REQUEST

Current Zoning: R-12MF(CD) (Multi-Family Residential, Conditional) Proposed Zoning: N2-A(CD) (Neighborhood 2-A, Conditional)

Approximately 3.16 acres located west of Marsh Road, south of Auburn Avenue, and east of Hartford Avenue.

The petition proposes the development of up to 37 multi-family attached units. The site is currently developed with a medical office.

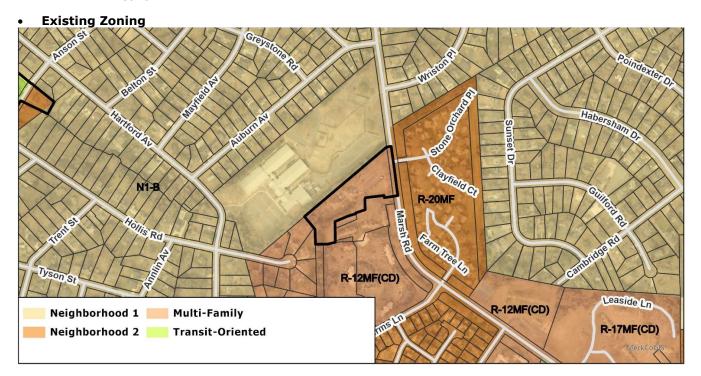
- setbacks into their development, establishing continuity of Marsh Road's streetside character.
- The front of the property features a landscape berm with mature trees that partially screens the existing development. The site plan shows seven units within the landscape berm, offering a site design bringing units closer to the street and notably deviating from the existing character of Marsh Road. The inclusion of units within this area also reduces open space opportunities on the site.

- Multi-family residential areas in the vicinity typically include shared community amenities, such as open spaces or recreational facilities, and common parking areas. The petition features minimal open space or recreational facilities.

- Public open spaces, such as small parks and greenways, and natural open spaces, such as tree preservation areas, are important features to serve the community and meet the intent of a Neighborhood 2 or Neighborhood 1 Place Type. Multi-family residential developments on smaller sites can accomplish meaningful open space in activating common open space areas where possible with substantive minimum dimensions and commitments to enhanced amenities.
